Donald C. Cook Nuclear Plant Units 1 and 2
ANNUAL ENVIRONMENTAL OPERATING REPORT

Annual Environmental Operating Report

January 1 through December 31, 2000

ATTACHMENT A
SGRP ENVIRONMENTAL REVIEWS

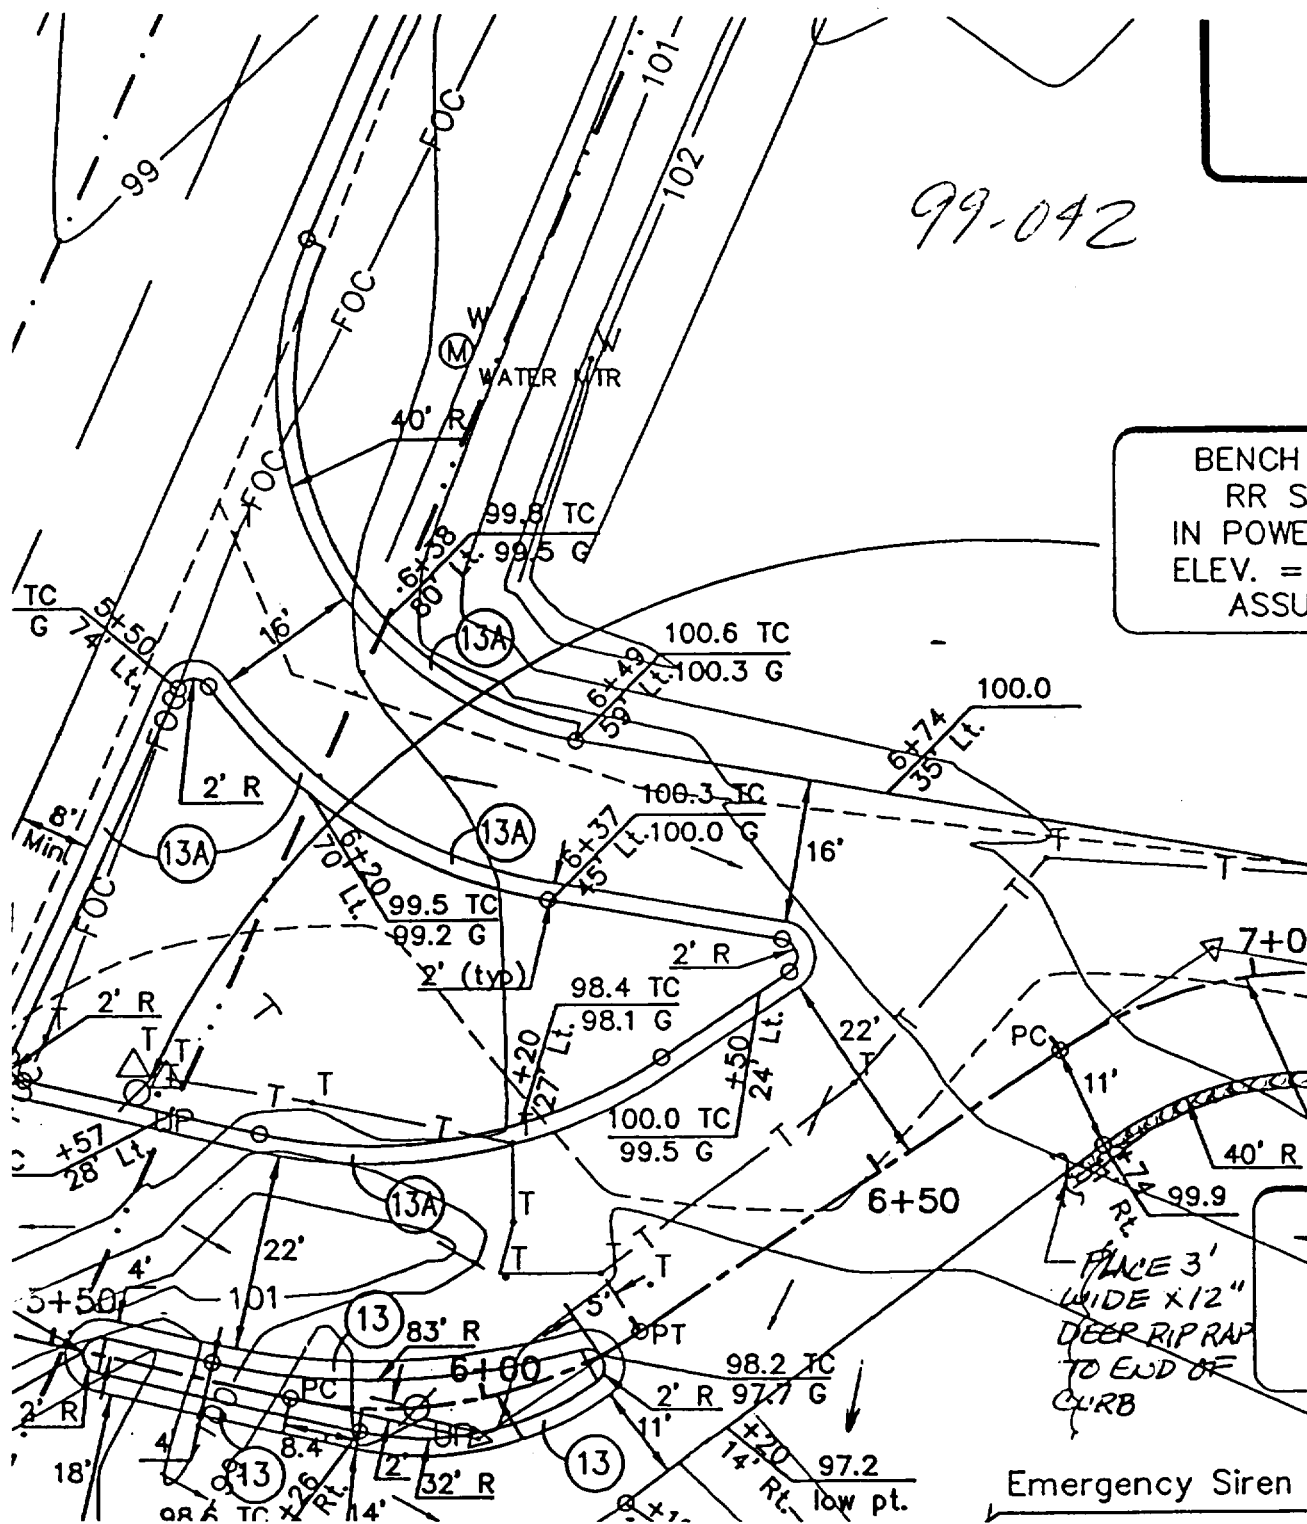
CONSTRUCT A SWALE TO CONVEY RUNOFF FROM NEW INTERSECTION AT RED ARROW HIGHWAY. WORK WILL INCLUDE CLEARING A PORTION OF THE EXISTING SWALE THAT WILL RECEIVE RUNOFF FROM NEW SWALE. SEE ATTACHED DRAWING, C49096-RS807.

Ensure stumps + mulching are done promptly to avoid erosion of the swale.

Senay Melby agrees with the attached plans - (MDEQ storm water).
Include the changes in the SUP3 Annual review.
The area will also need to be inspected semi-annually.

99-043

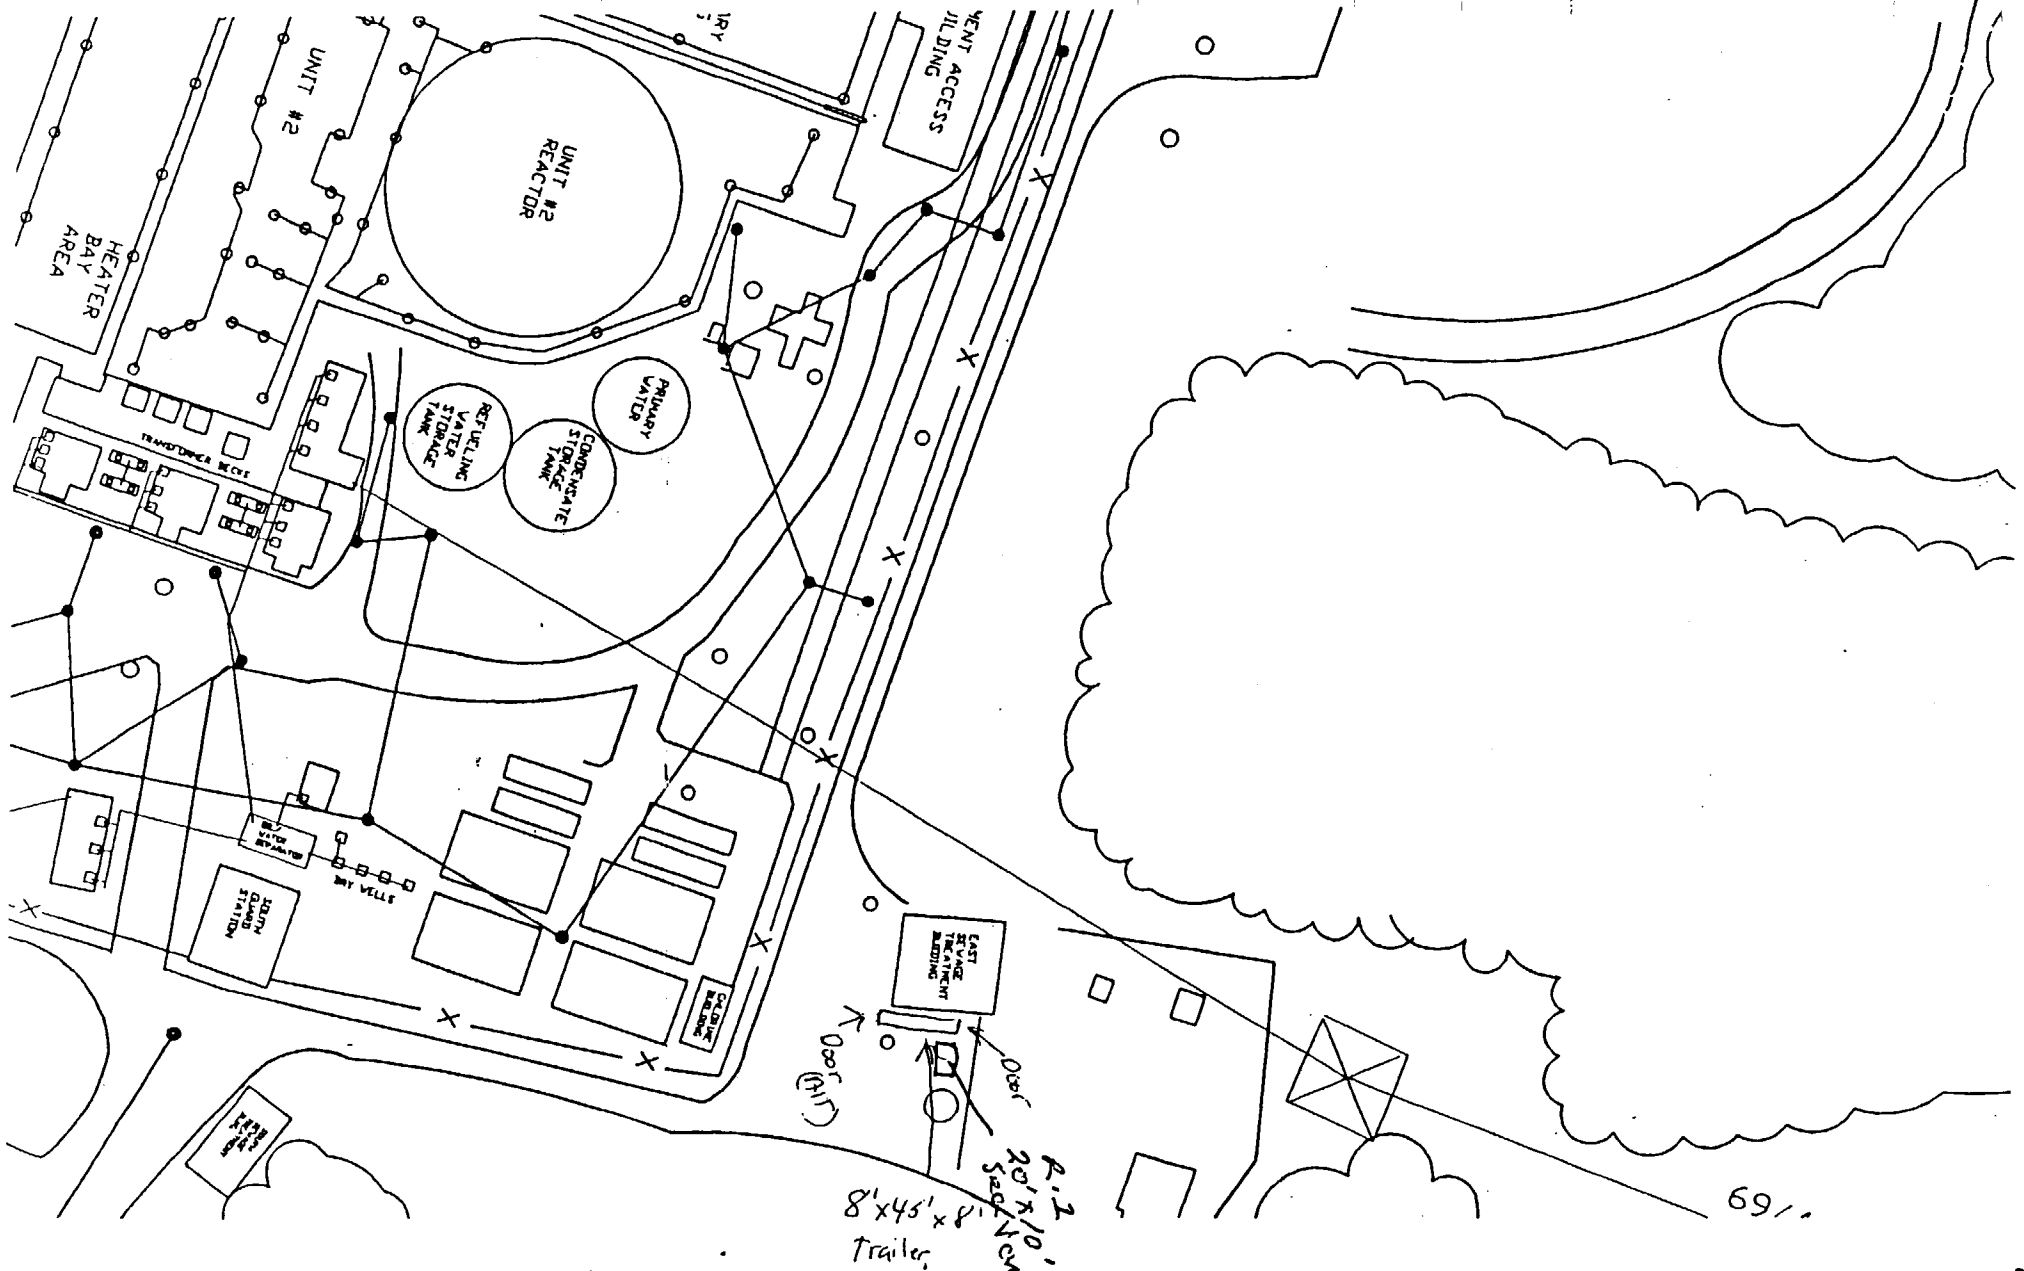
Chemical storage permit per PMI-2160 is required
if chemicals will be stored in the trailer. B. Harrington 9-28-99

No Digging - No Bulk Liquids therefore No Dunes Permit or B.C. erosion
required. Enclose trailer - No Stormwater concerns.
Add a 20' x 10' Sea Van ga 11-10-99

ATTACHMENT TO DIG PERMIT
No. 1059
REV 0 ~~RBB~~ 9/28/99

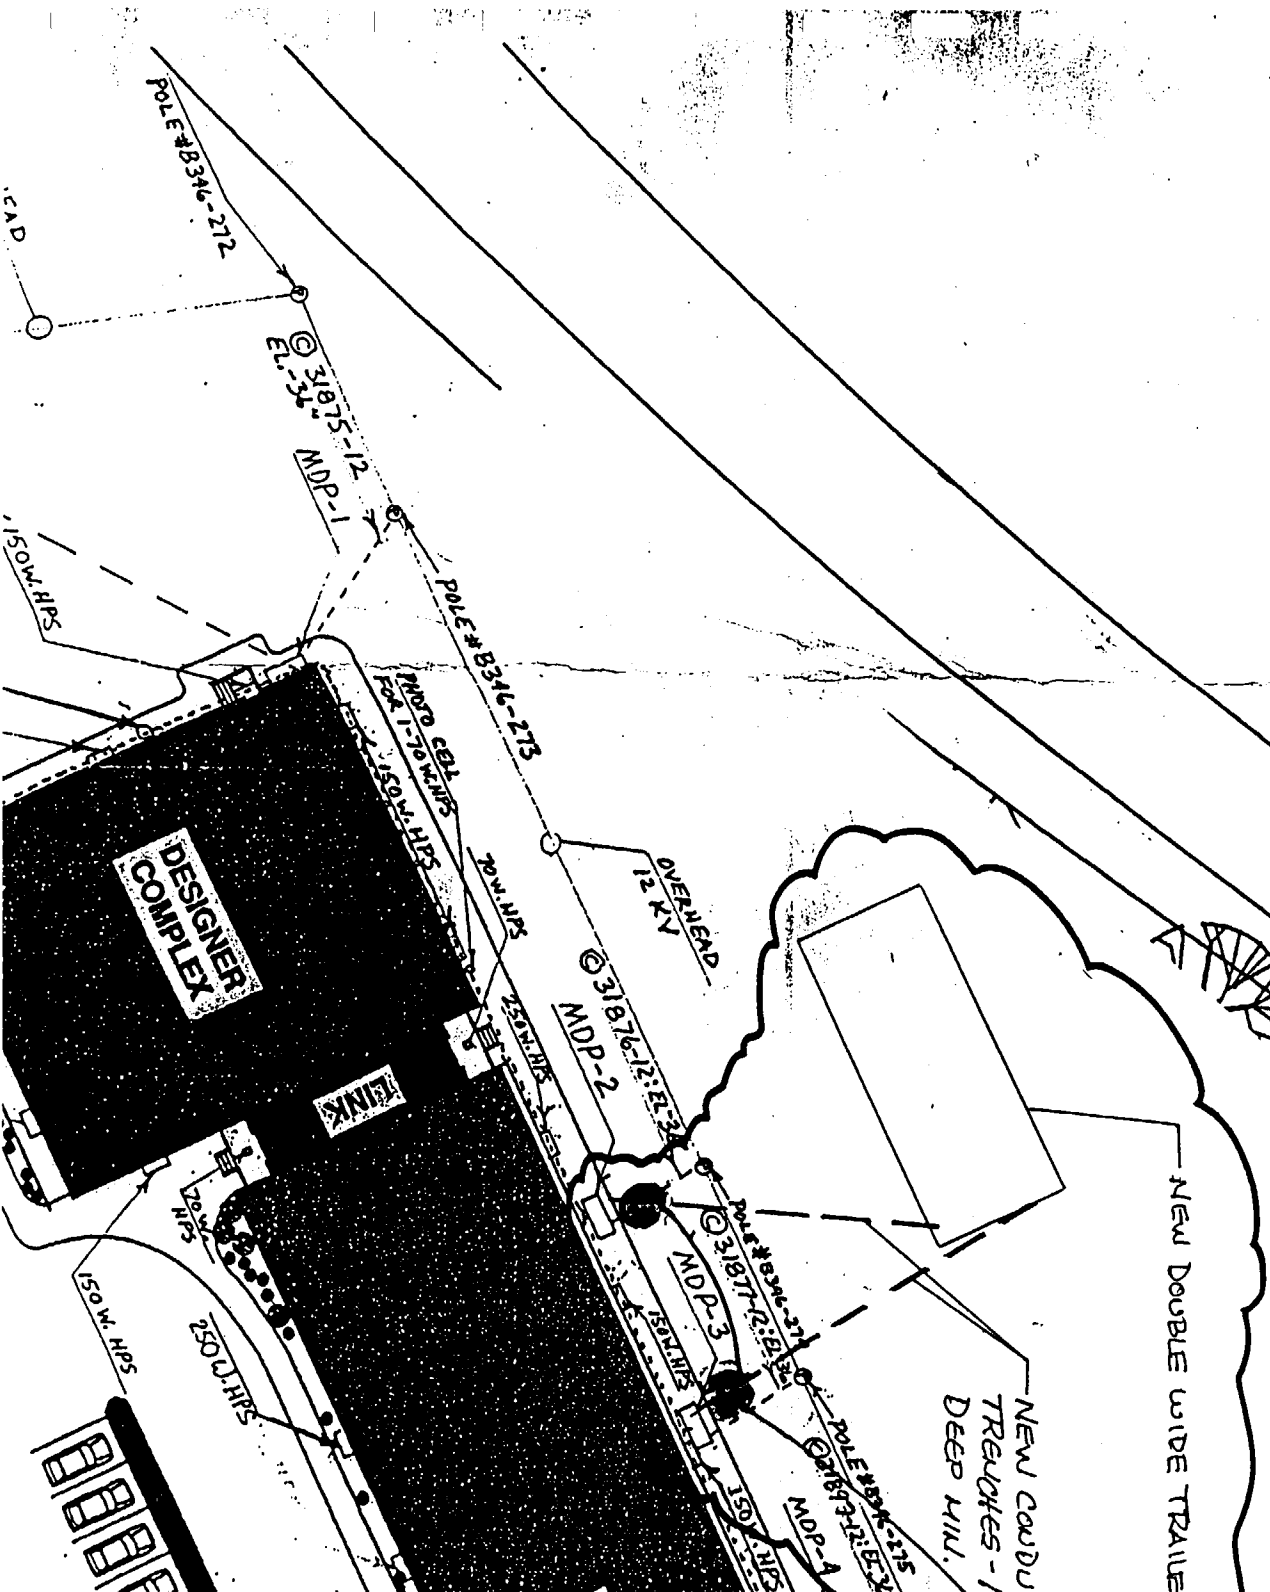
Prevent soil contamination of any stormdrains in
Plant access Road. Re Use Soil as Fill when
Trench work is complete

>500 feet from lake Crit Dunes: Exempted in
Previous Permit for the area since it is
no where near Dunes
